# County of Fairfax, Virginia

## STAFF REPORT

### SPECIAL EXCEPTION AMENDMENT APPLICATION SEA 94-P-040

**PROPOSAL:** To permit the addition of an eating establishment and child care center/nursery school within commercial office building.

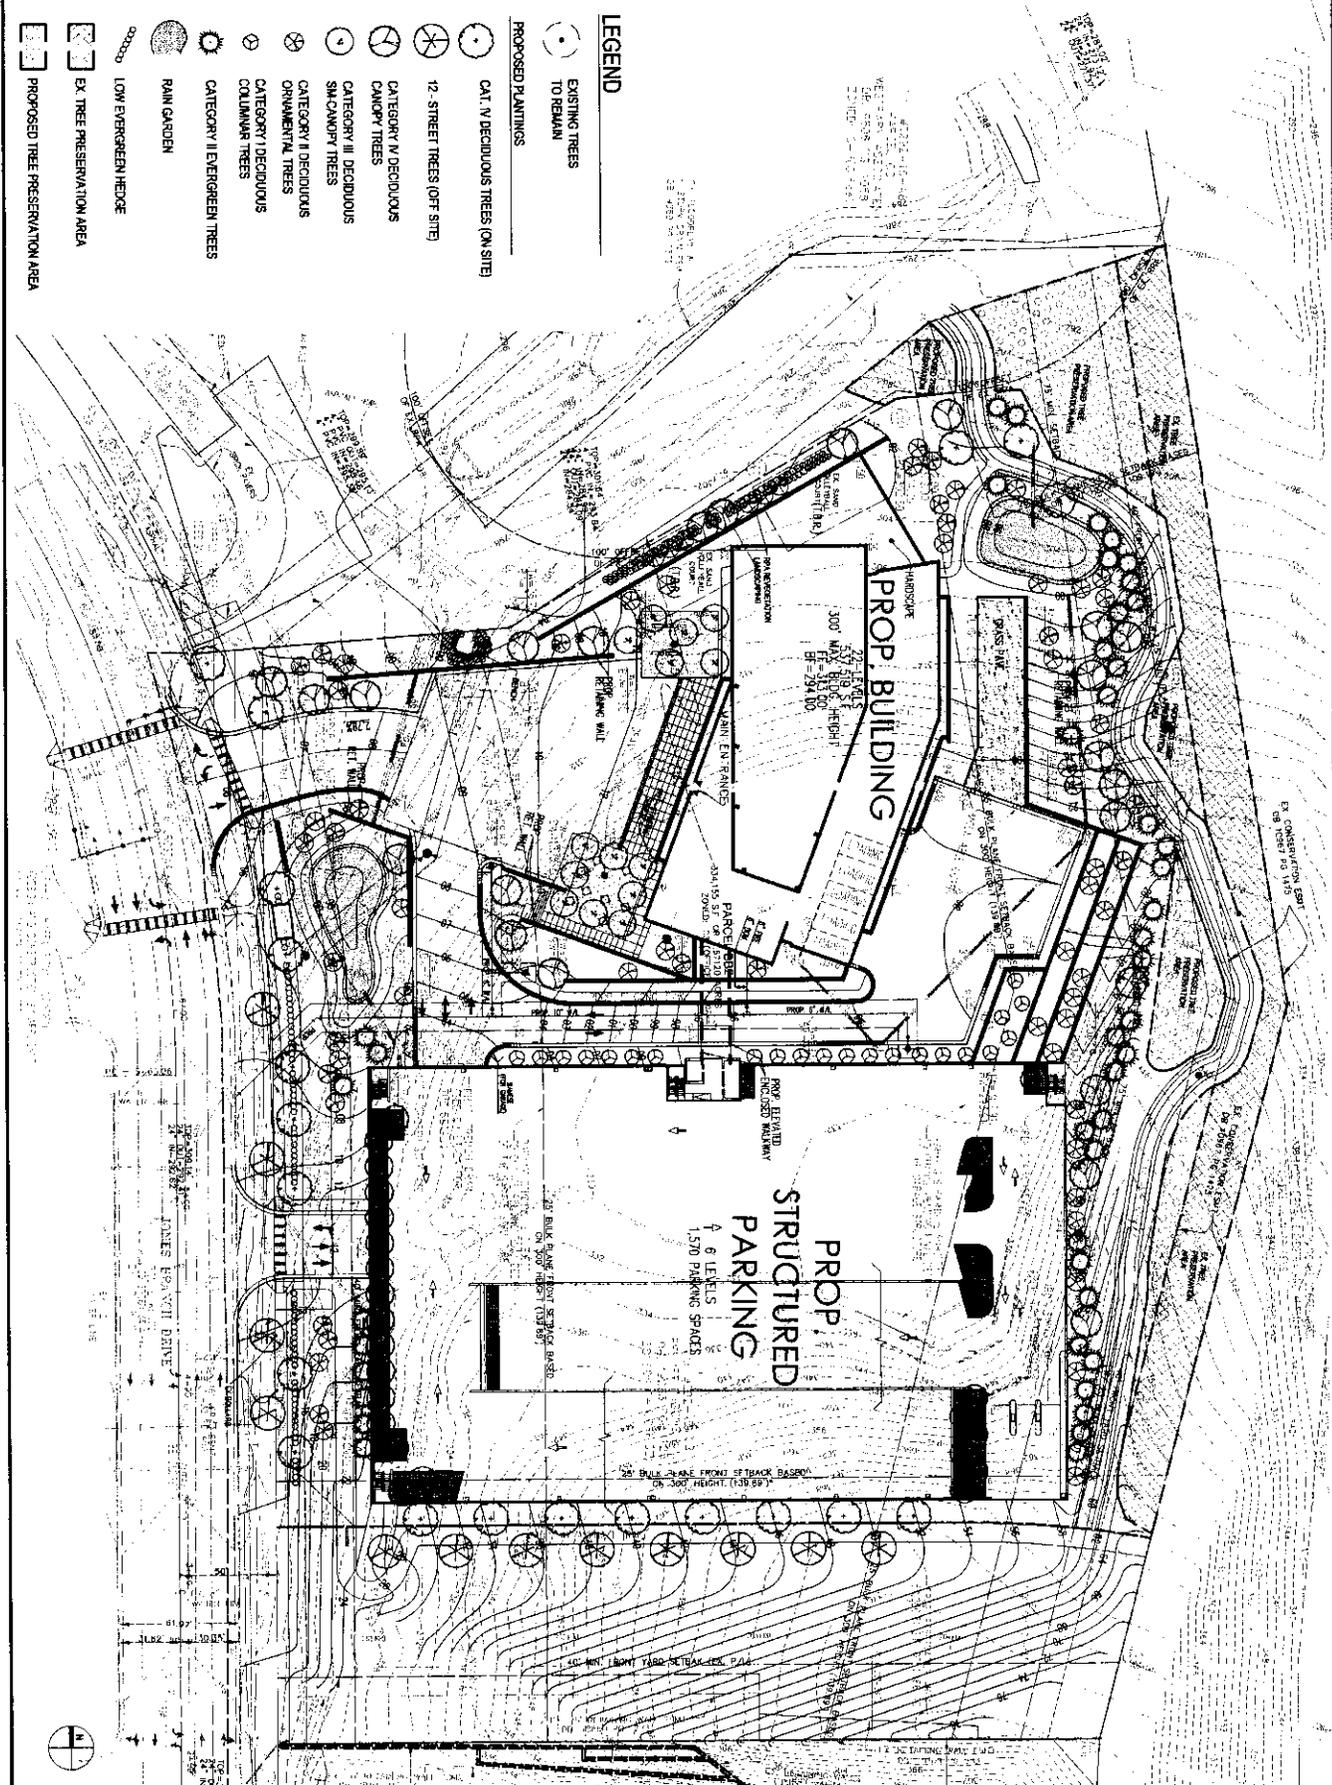
Staff has identified several planting locations depicted on the landscape plan that may be problematic. First, several trees at the western portion of the site, adjacent to Jones Branch Drive, are proposed to be planted inside an existing 15-foot wide Fairfax County Water Authority (FCWA) easement. In addition, several trees in the northwest corner of the site appear to be planted inside an existing 25-foot wide storm drain easement. If trees are shown to be planted within existing or proposed public utility easements, a letter of permission from the owner of such easement must be provided. Finally, several tree locations throughout the site are proposed to be planted within four feet of a restrictive barrier, which may have an adverse impact on the growth of the tree.

A note has been added to Sheet 10 of the SEA Plat, which states noting that all proposed plant material located within utility easements will be approved by the applicable parties prior to installation. Staff proposes a development condition which would require the applicant to obtain appropriate permission from the owner of the public utility easement in order to plant the trees as shown on the SEA Plat. Should permission not be received, the applicant will be required to relocate this landscaping on-site in substantial conformance with the SEA Plat or a SEA will be required. With the implementation of the proposed development condition, this issue has been resolved.

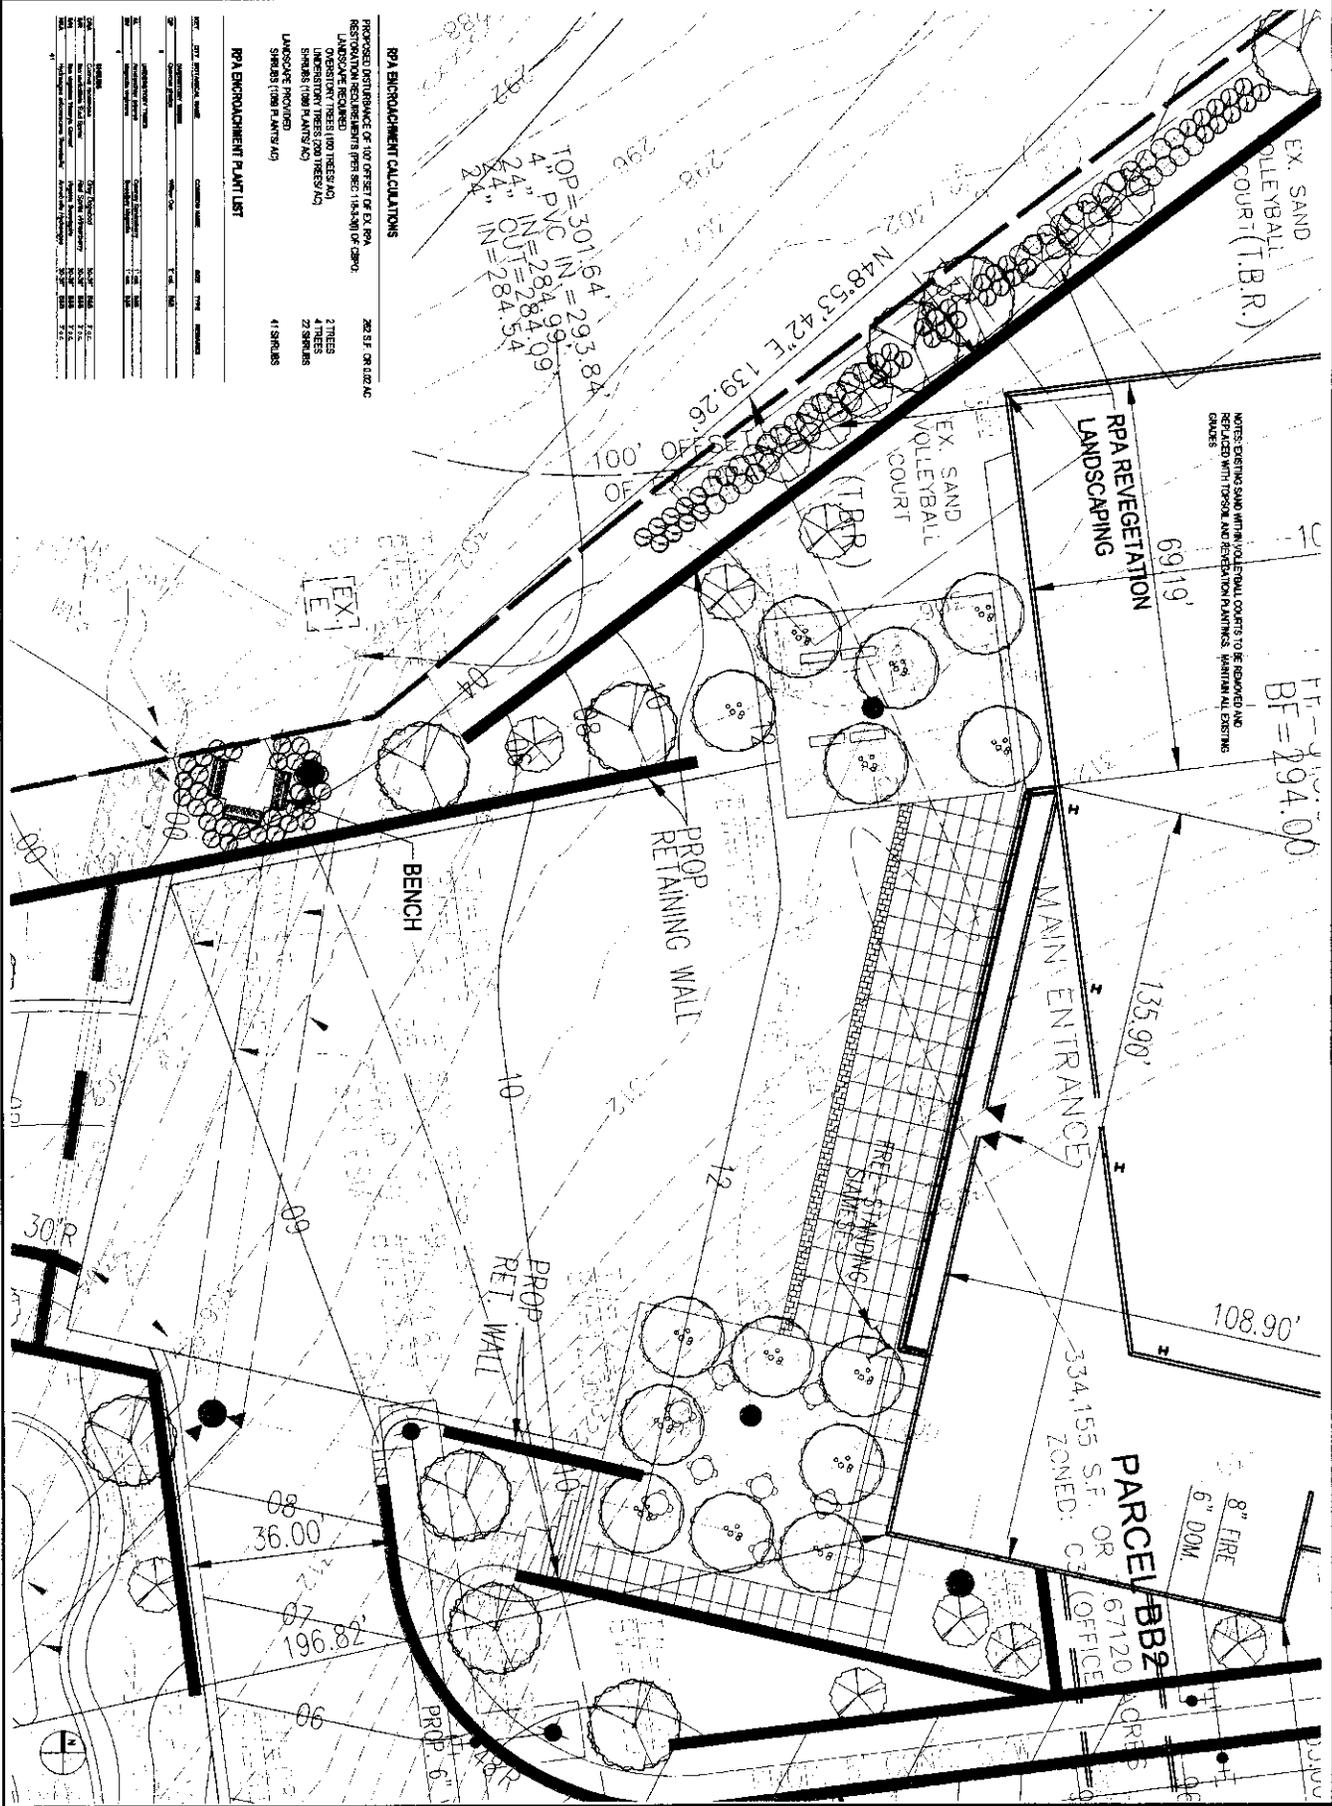
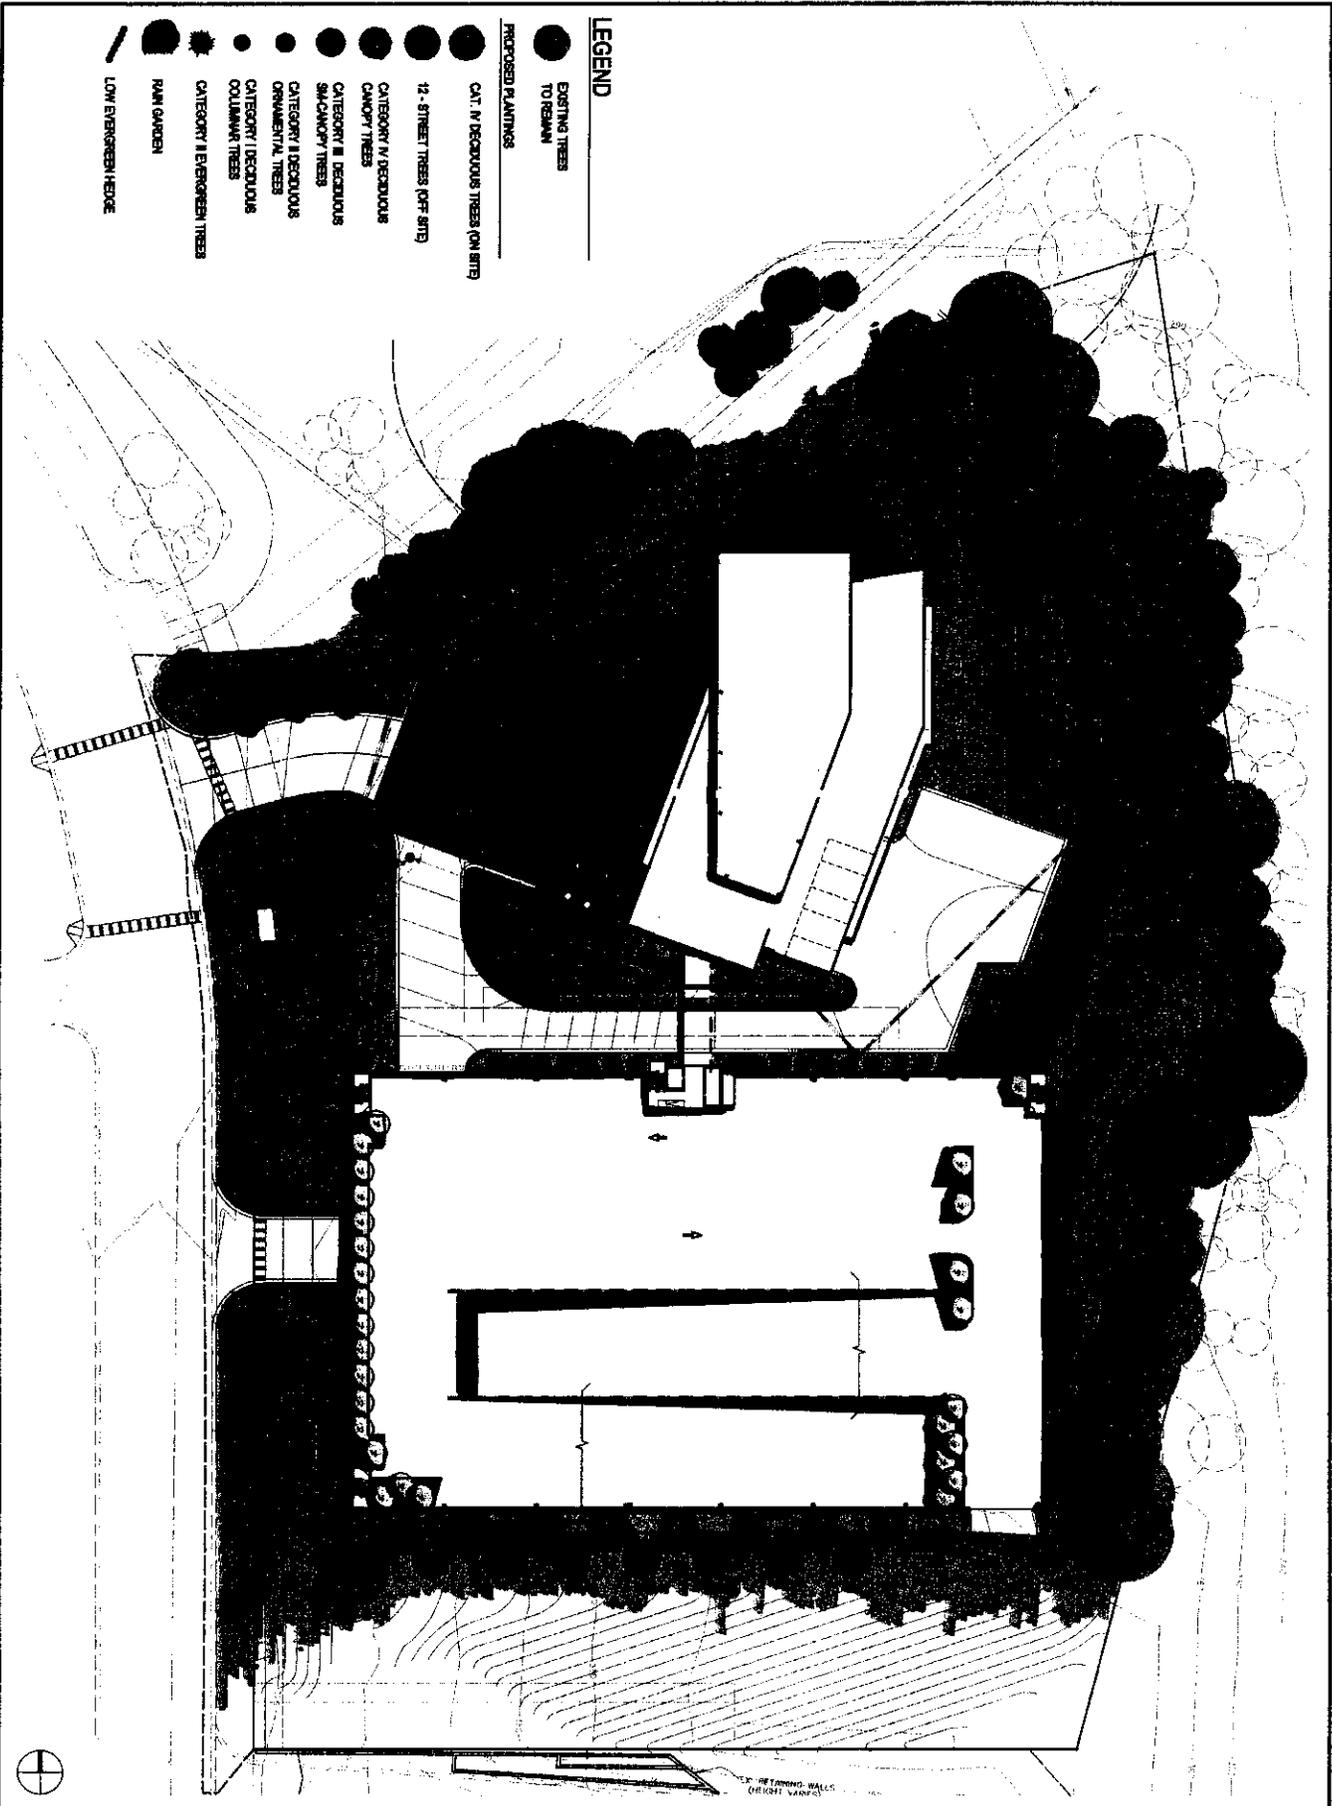
- 3. Comment:** The "On Structure Planting Detail" shown on sheet 10 of the SEA references structural soil as a planting medium. It is unclear why structural soil is proposed in this environment.

- 4. Comment:** The "On Structure Planting Detail" shown on sheet 10 of the SEA does not include the dimensions and soil volume of the planting areas.
